Your feedback on the Glenvar Road and East Coast Road improvements

Auckland Transport (AT) is applying for funding to make improvements to parts of Glenvar Road, a short section of Ashley Ave and East Coast Road (between Glenvar Road and Oteha Valley Road).

We consulted on this proposal from 8 November to 8 December 2019 and received 420 submissions.

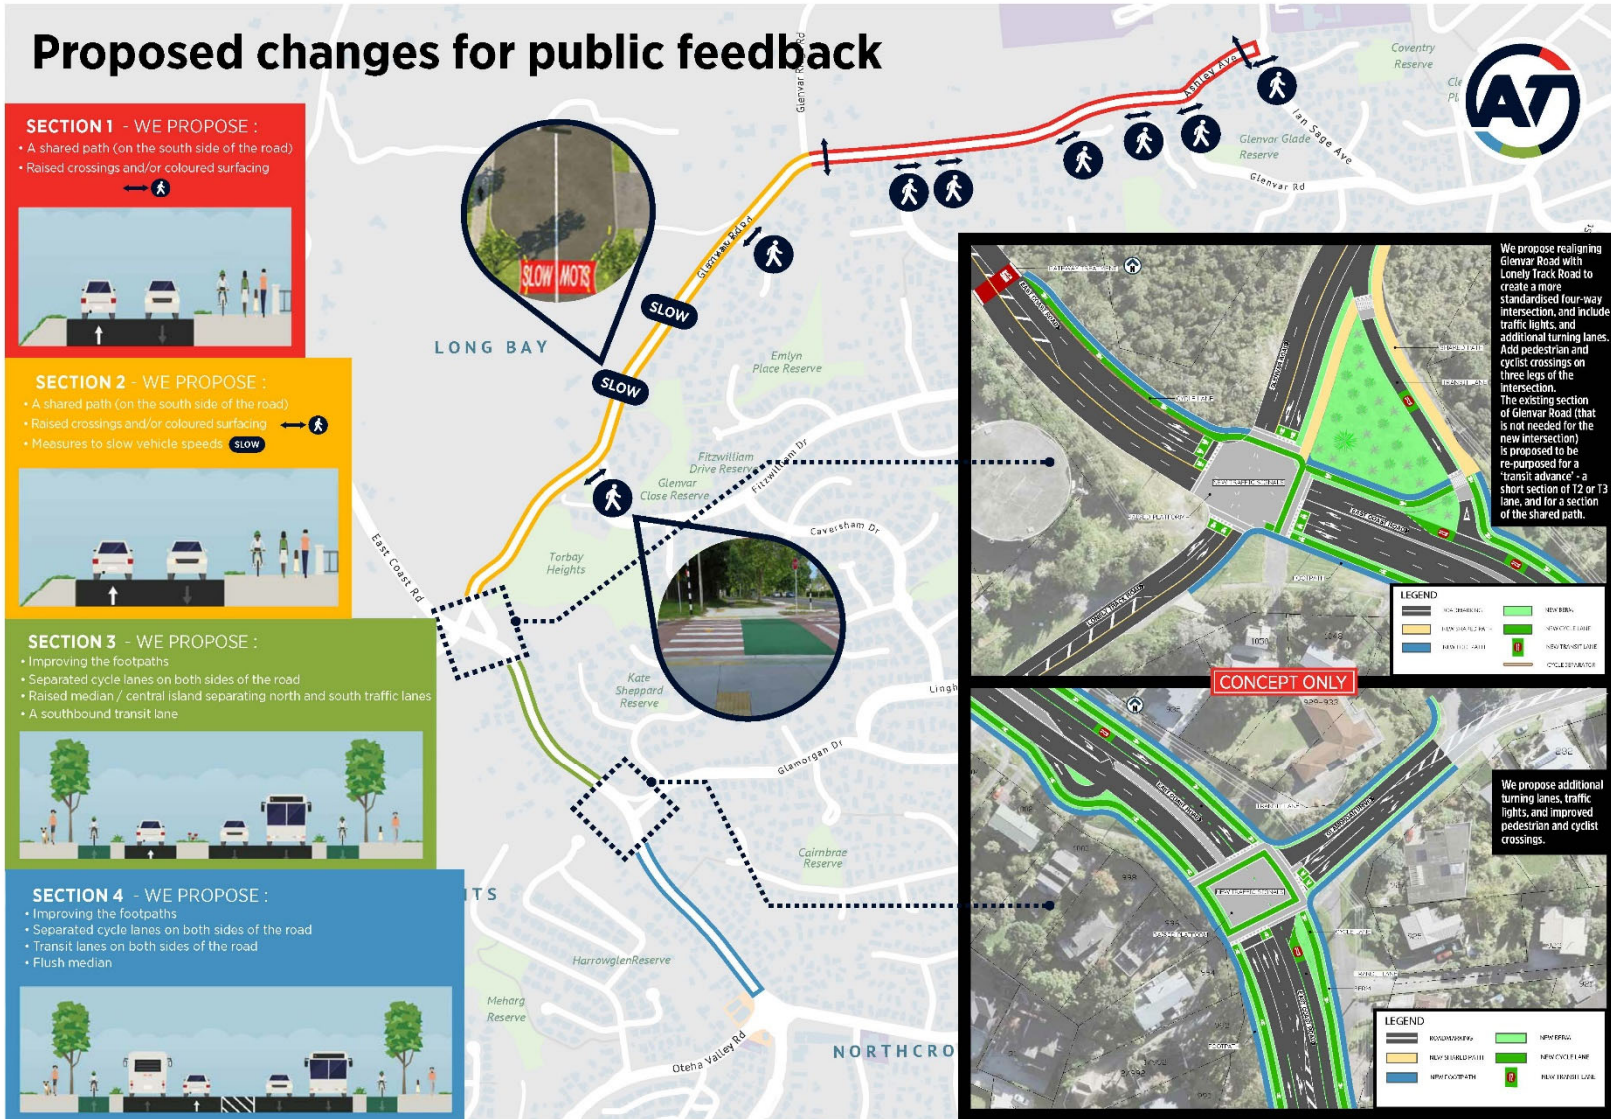
Intersection Glenvar Road/ East Coast Road/ Lonely Track

Bike Auckland previously expressed concern that drivers entering and leaving the higher speed zone to the north presented a danger here. We are pleased to see the inclusion of a gateway treatment ahead of the intersection. However, please ensure that the gateway treatment does not pose a pinch point for on-road riders in detail design.

However, we would like to see the addition of a northbound cycle lane out of the intersection for at least the first 30m or so on the downstream leg to the northeast.

We support the advanced stop boxes on all legs signalling that cyclists are allowed to continue using the road lanes - particularly when going to and from roads that don't receive protected lanes.

Taking the slip lane from Glenvar Rd further south before joining with East Coast Road and raising the slip lane crossings retains safety for cyclists operating around the slip lane and means cyclists don't have to deal with slip lane traffic while crossing the intersection.

The interface between the separated cycleways and the shared path at the raised crossing across the slip lane seems not yet fully worked through - please avoid a design that creates an unnecessarily sharp bend for right turns of riders using the East Coast Road protected lane, after they cross the southern raised table.

Design suggestion in feedback	AT response
<p>Intersection Glenvar Road/ East Coast Road/ Lonely Track: We would like to see the addition of a northbound cycle lane out of the intersection for at least the first 30m or so on the downstream leg to the northeast. This cycle lane should be a transition zone between protected facilities south of the intersection and no facilities at all to the northwest. This short facility should be explicitly paint-only...”</p>	<p>This will be considered further at the next stage ‘Detailed Design’.</p>
<p>Northbound riders on East Coast Road should have a design that allows them to legally “detour” around the signals / get a green signal on the separated bike lane on East Coast Road - as long as the pedestrian crossings conflicting with this have not been called.</p>	<p>The crossings are proposed as raised crossings and so this can be considered further at the next stage ‘Detailed Design’.</p>

Attachment 1: Proposed designs

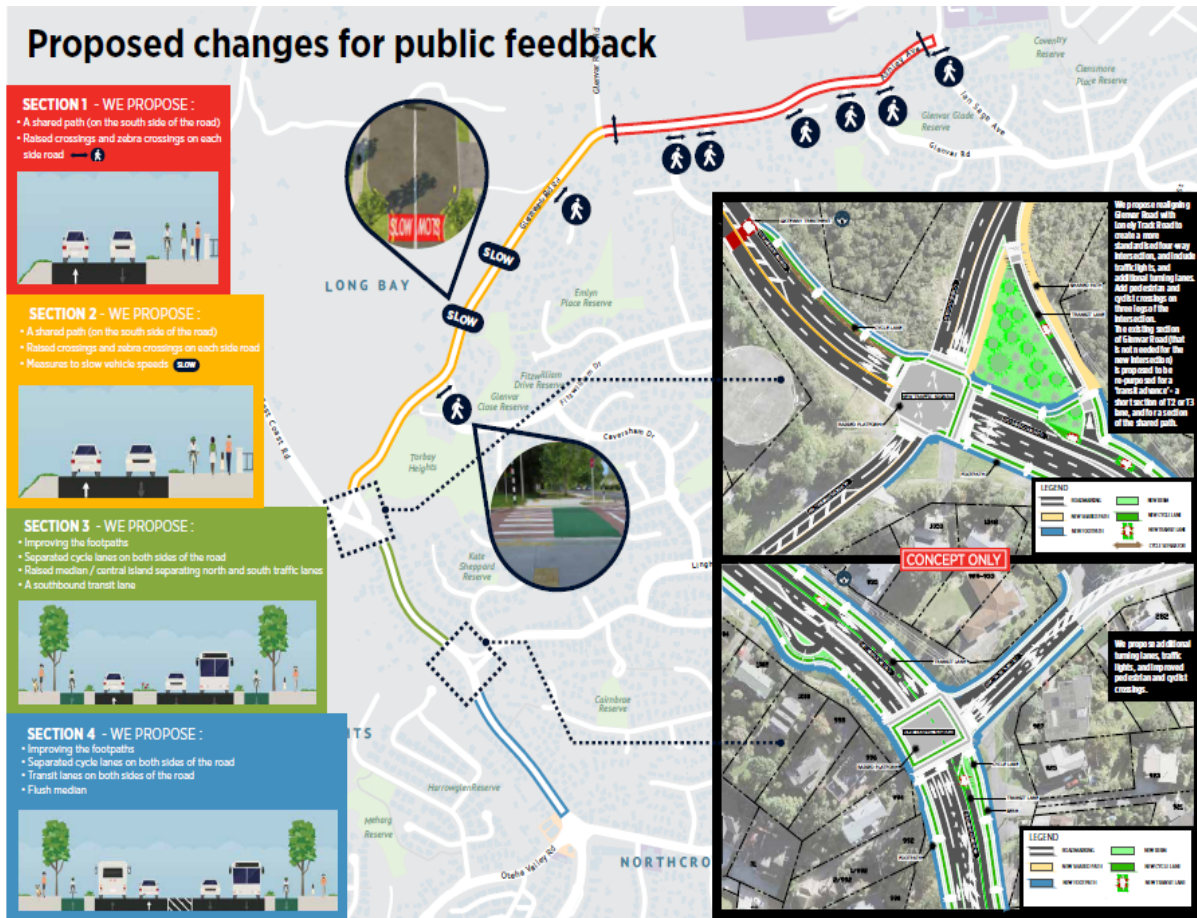
Section 1

While not best practice, we acknowledge the geometric constraints in this area, and thus the proposed shared path. We strongly support the use of raised side road crossings. Raised side road crossings will be crucial in creating a usable and safe path. Ideally, they should also provide legal priority for people on bikes and on foot.

Design suggestion in feedback	AT response
Shared cycle and pedestrian paths	
Glenvar Rd, section 1: Must have separated footpath and a cycle lane separated from traffic by a berm or a barrier of some kind.	<p>There is limited available space on Glenvar Road and the topography is challenging. While providing a footpath on both sides of the road and / or adding separate cycling facilities would normally be AT's preferred option, in such a location it would involve a significant amount of work that would be well beyond the scope and budget of this project. It would also be extremely disruptive, and the economics would not likely add up at this time.</p> <p>The shared path we are proposing, while not a perfect solution – because people on bikes and pedestrians would prefer their own space, is all we can fit in the available space. Nevertheless, the shared path proposal for Glenvar Road will provide a safer and more enjoyable facility for people walking and on bikes compared to the existing situation. Furthermore, the proposed crossings at each side road are intended to provide priority and safety.</p>
